# **Matanuska-Susitna Borough LiDAR & Imagery Project Quality Assurance Report Point Mackenzie Block**

**Written by Rick Guritz**

**Alaska Satellite Facility**

**April 15, 2012**

Figure 45, Seam in Bare-Earth DEM (Left) Corrected (Right).

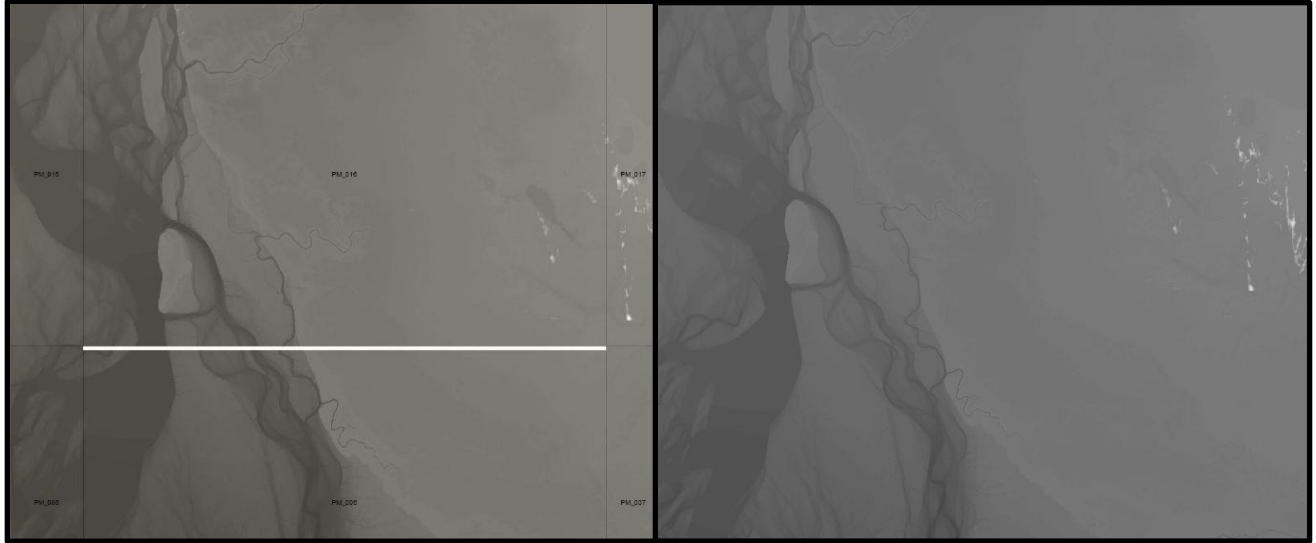
**Detected Seam in bare-Earth DEM** – On 11/09/2011, an observed seam was reported when trying to mosaic bare-Earth DEM tiles. This seam was several pixels wide running west to East between two sets of tiles (see Figure 45).

Figure 46, Single Hydro Breakline Inaccuracies.

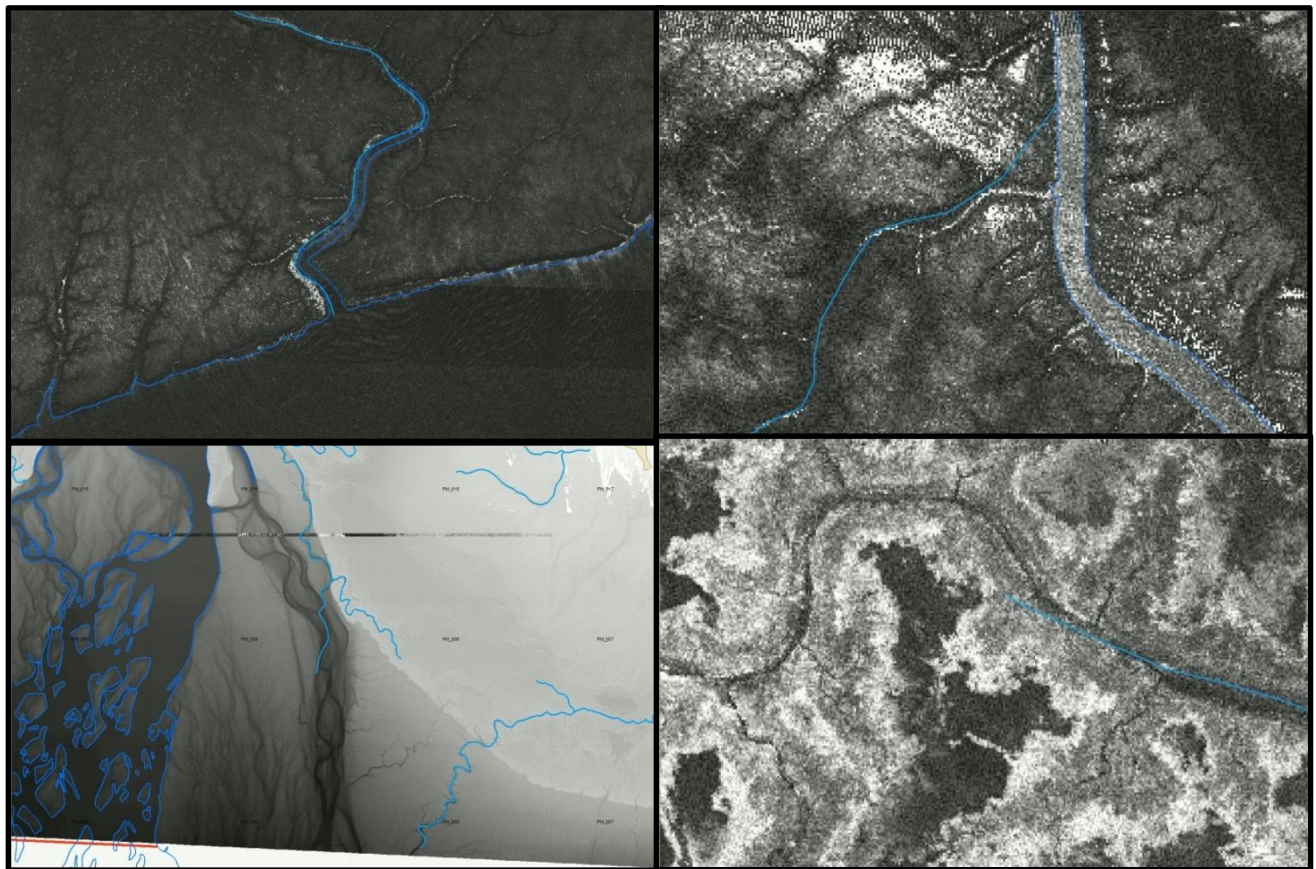
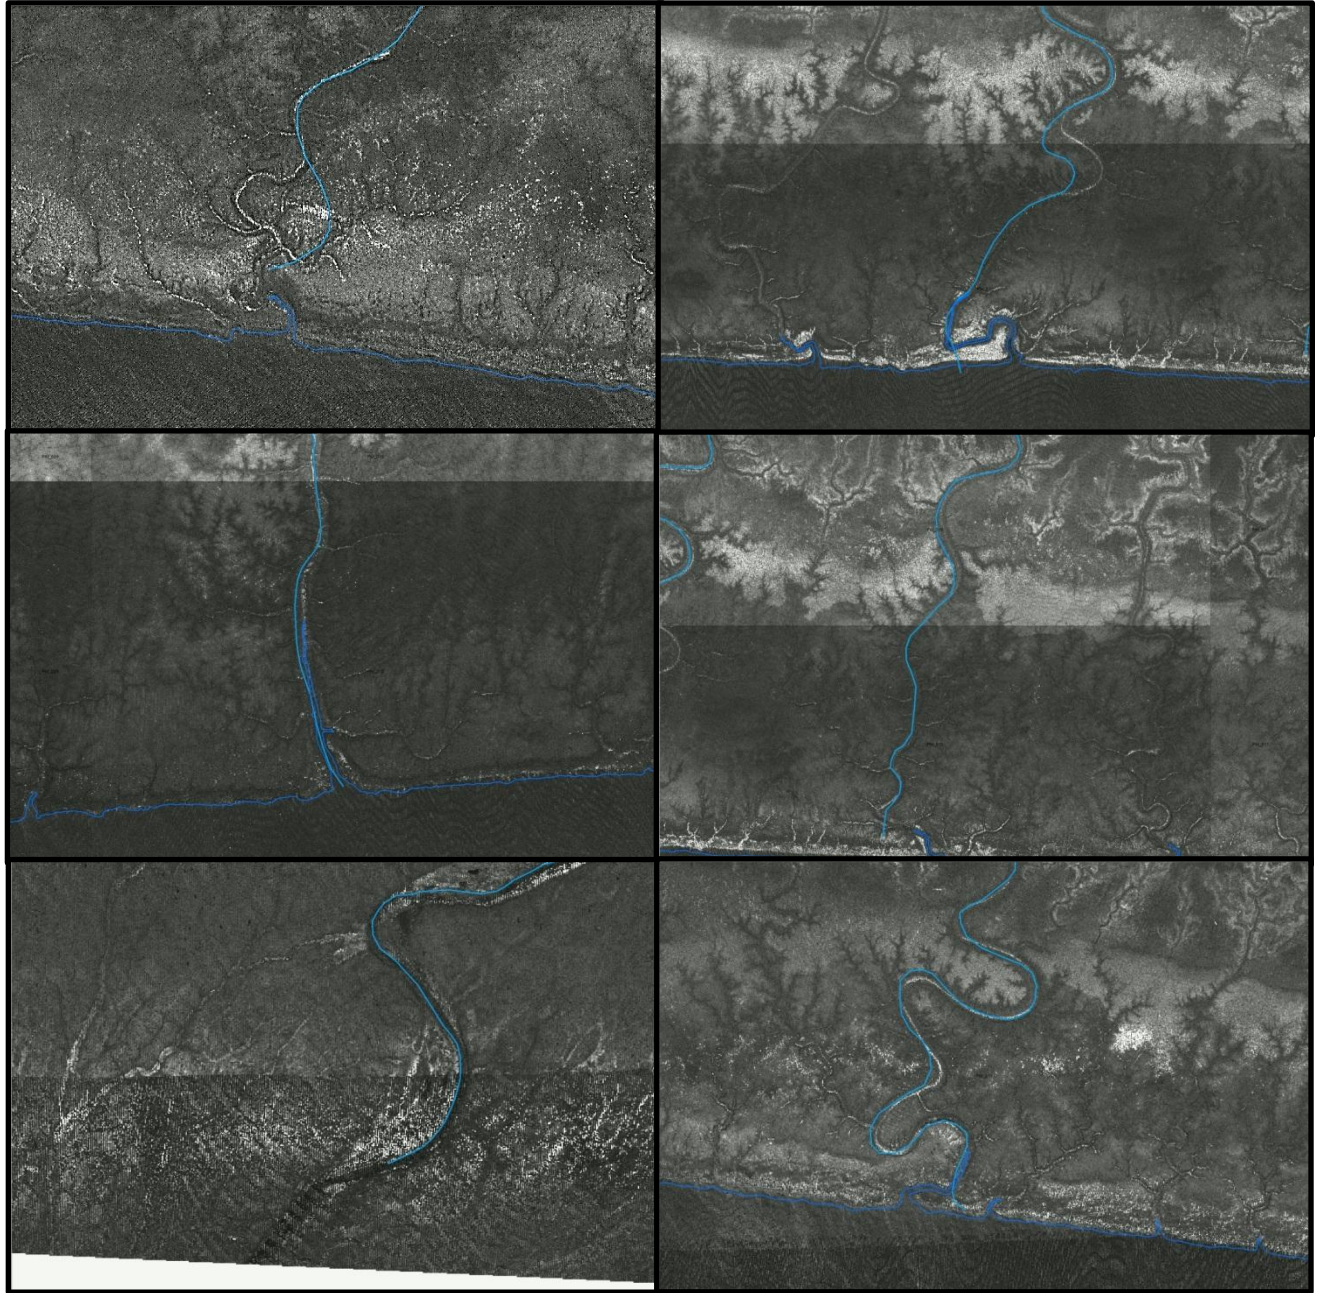
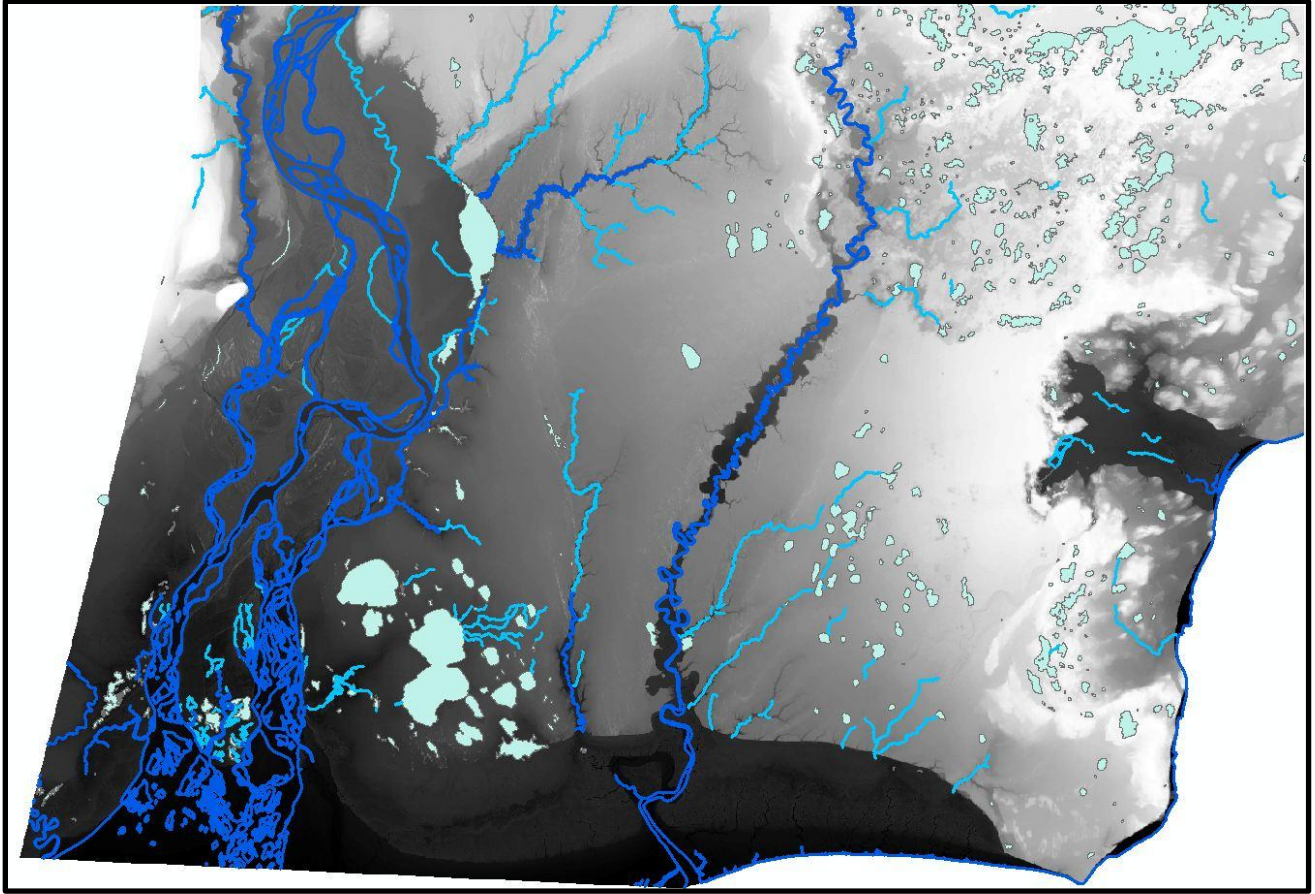
**Anomalies identified in single breaklines** – On 11/10/2011, ten screen captures were provided to Aerometric identifying inconsistencies between single breaklines and either LiDAR intensity data or the bare-Earth DEM (see Figure 46-47). These were primarily over channels in the mud flats. After review, Aerometric decided to remove most of these breaklines because they were too difficult to determine accurately. The corrected hydro layers have very few breaklines in the mud flats (see Figure 48).

Figure 49, Interpolation Artifacts in First-Return DSM (Left), Corrected (Right).

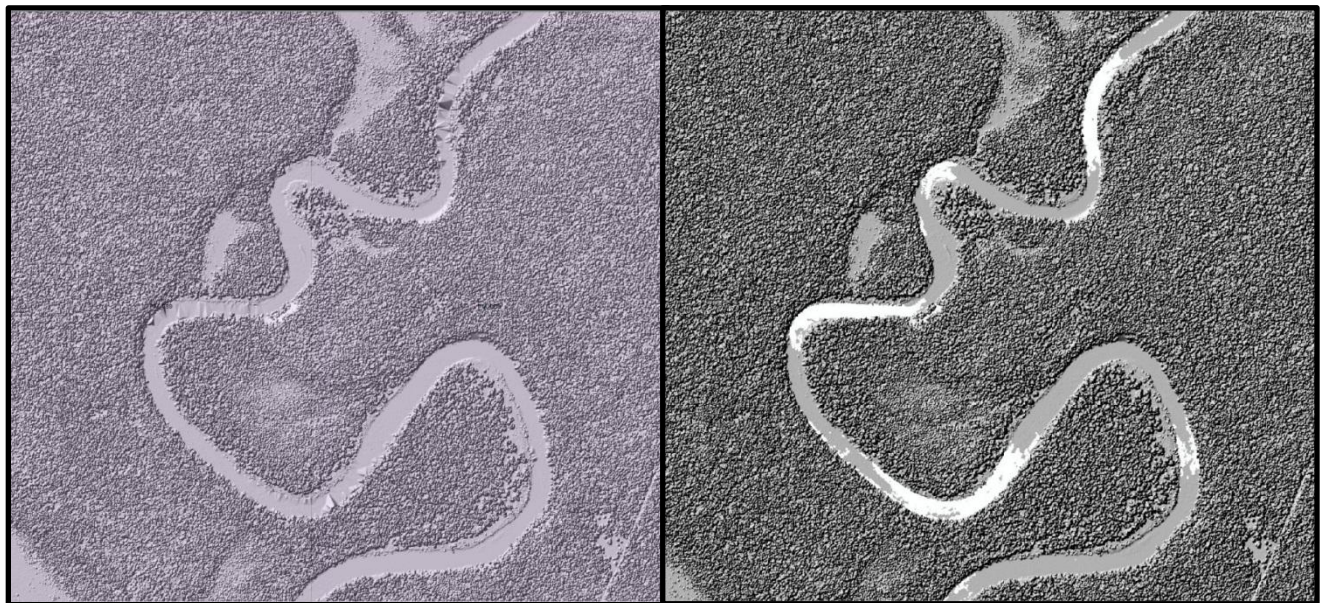
**Anomalies in First Return DSM** – On 11/11/2011, interpolation errors were observed in portions of the Little Susitna River (See Figure 49). In a true first return product, the LiDAR data should be evaluated on a cell by cell basis using the delivery grid as the basis for evaluation. All valid LiDAR returns (excluding points marked as withheld, class 1 and 7) should be evaluated for the highest return for that cell. For cells over water, there may not be a valid return for that cell, in which case the cell should be set to NoData. In discussion with Aerometric, they were using interpolation to fill holes over water which is undesirable. They were also using a gridding process that did not provide a true first return gridded product. After discussion, Aerometric was asked to change their processing methods to something that would provide a true first return product. This change was considered essential for a true canopy height product to be generated and for cross validation between gridded data and LiDAR point cloud data.

Figure 50, Seams in LiDAR intensity mosaic (Left), corrected (Right).

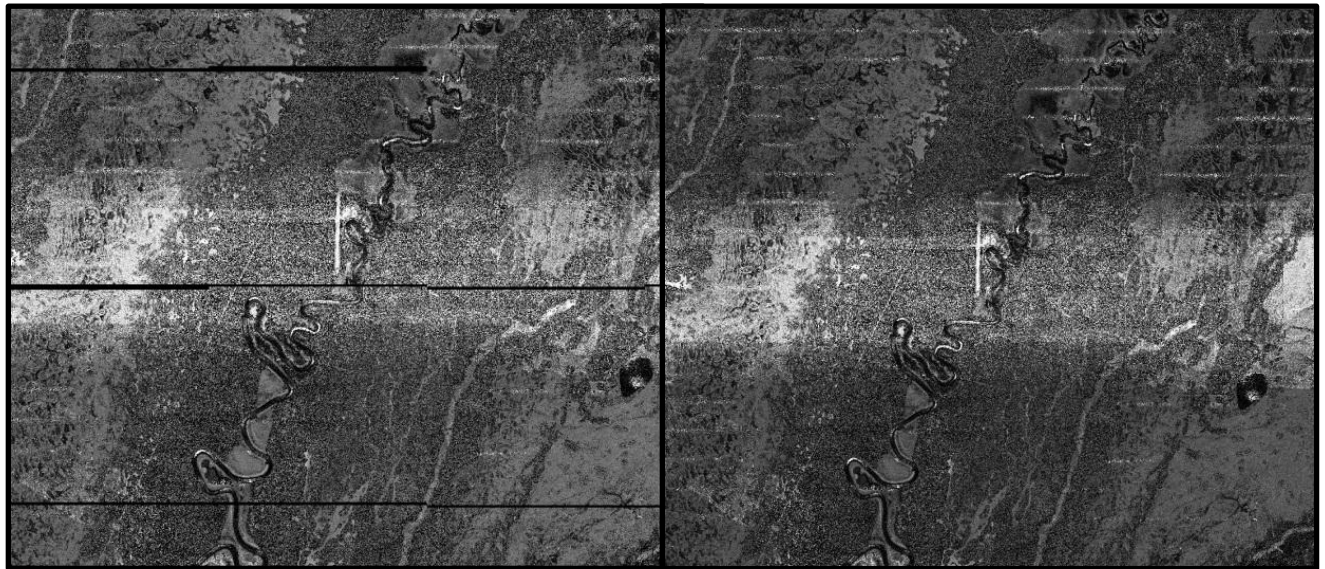
**Detected Seams in LiDAR Intensity data** – On 11/11/2011, observed seams were reported when trying to mosaic LiDAR Intensity data (see Figure 50). The seams were very obvious running from West to East and up to several pixels wide in places. After further investigation by Aerometric, they decided to use raster catalogs within the block geodatabase for all raster grids for future deliveries. This change eliminated the presence of seams in the data. It also was a much improved method for delivering raster data than what was initially used.

Figure 51, Coverage Gap (Port) in First Return (Left), Extended (Right).

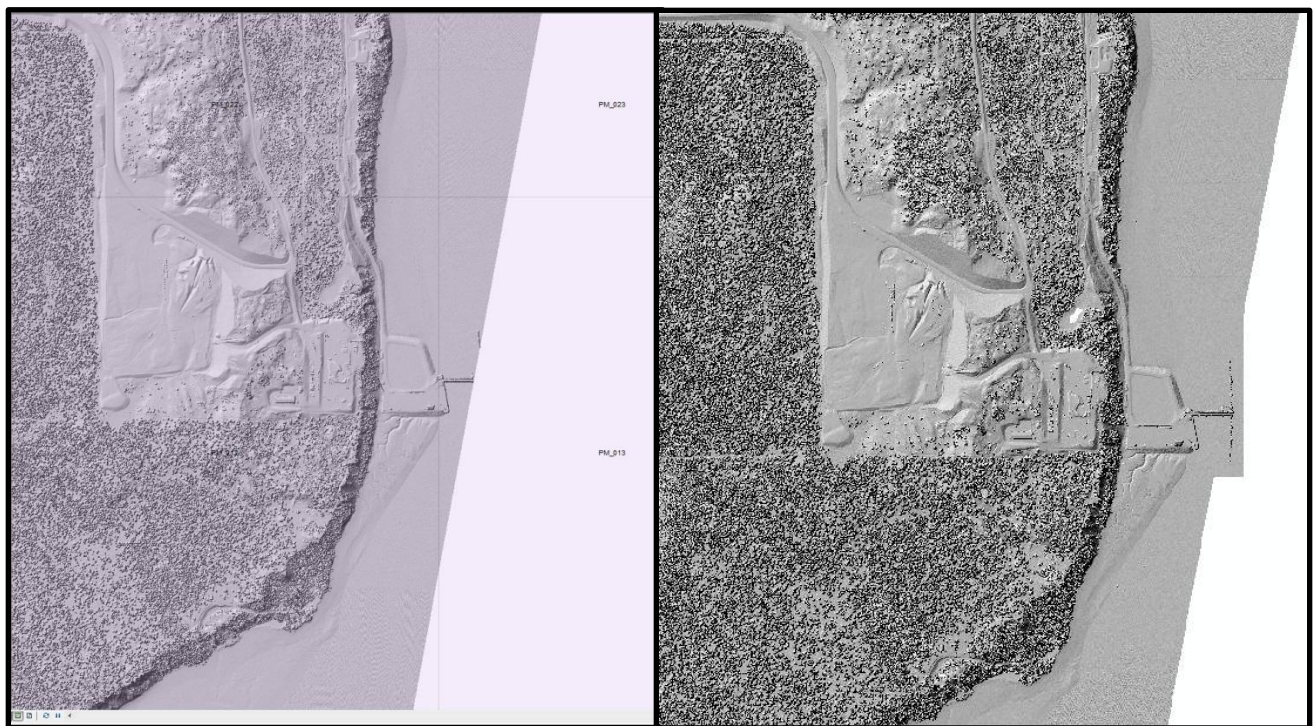
**Clipping of Point Mackenzie Dock** – On 11/11/2011, during visual assessment of the shaded relief product clipping of the Point Mackenzie dock was identified and reported (see Figure 51). An exception to the original block boundary was made to include the dock structure in both LiDAR intensity and first return DSM. This is an important structure that should be included in the resulting data. It should be noted that the original coverage requested by Matanuska-Susitna Borough GIS staff was the source of the error. Fortunately, the LiDAR coverage could be adjusted to cover the entire dock and breakwater.

Figure 52, Canopy Height – FR minus BE, Regions of negative values over -1.

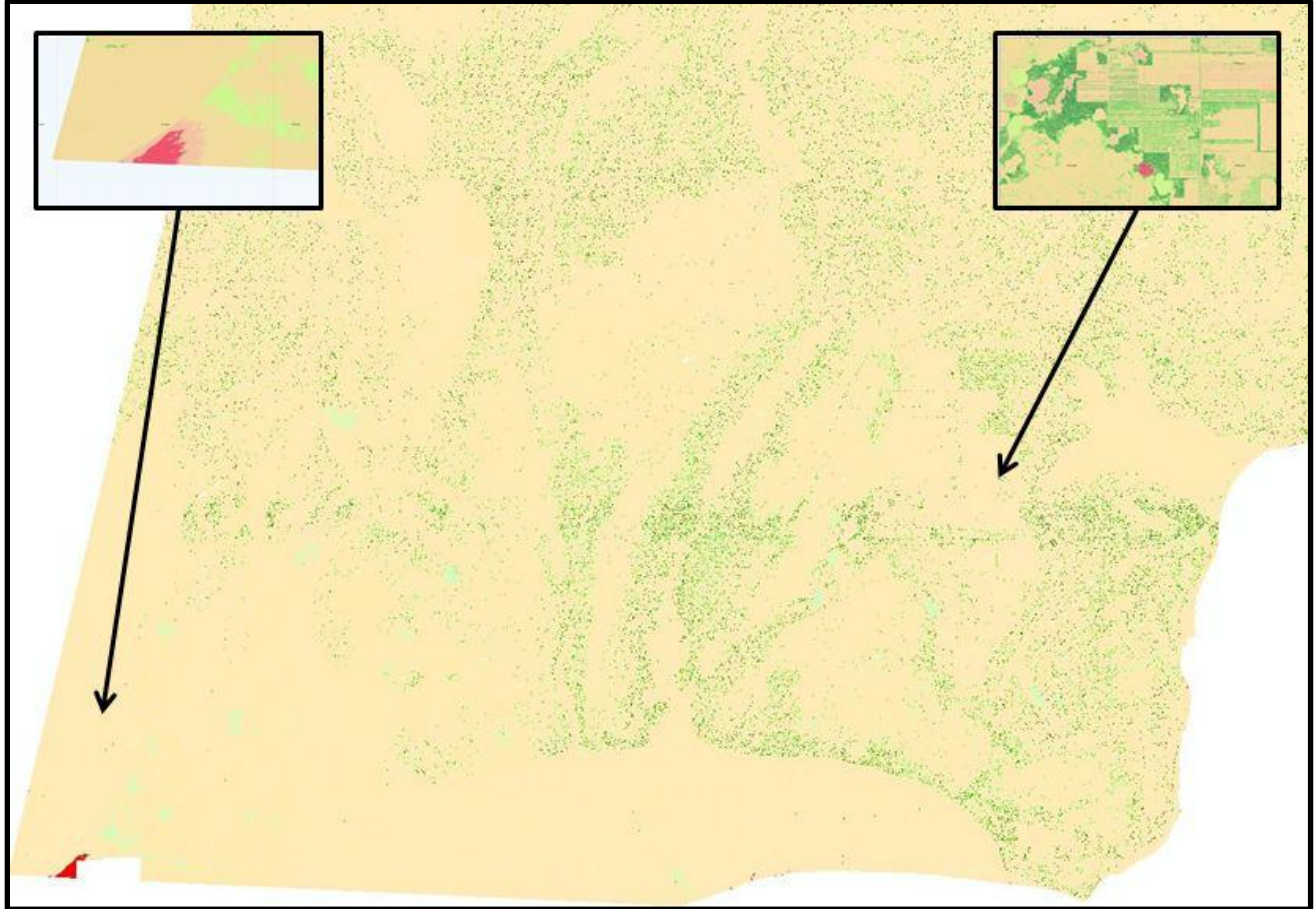
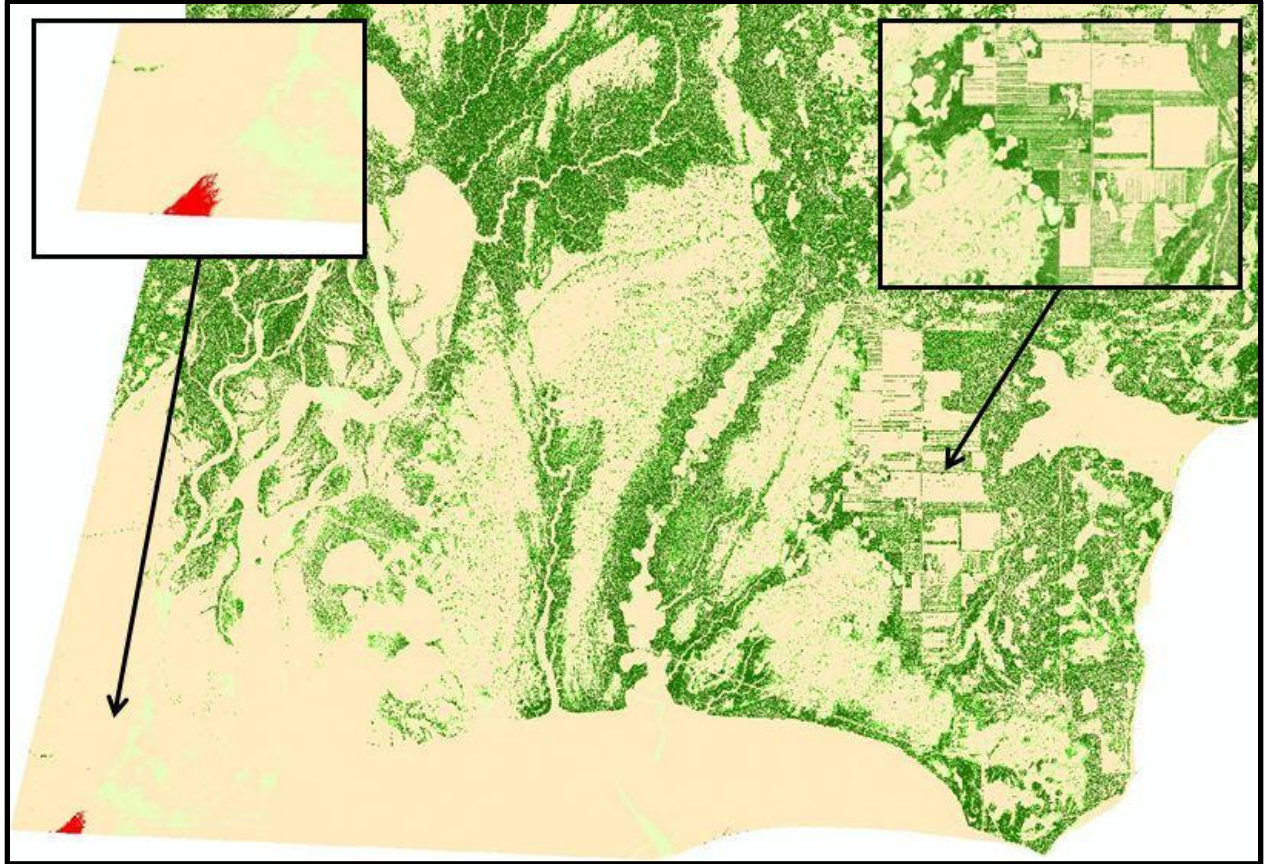
**Negative values in canopy height difference** – On 11/22/2011, negative values greater than -1 foot was observed in two locations of the Point Mackenzie block (see Figure 52). One was in the Susitna River delta, which was attributed to tidal fluctuations. The other was an area near some agricultural fields. One of these errors was eliminated when the rigorous first return DSM product was generated (See Figure 53). For our evaluation, we expect noise levels to be on the order of plus or minus one foot. Any negative values greater than one foot are not real and should be eliminated in the data.
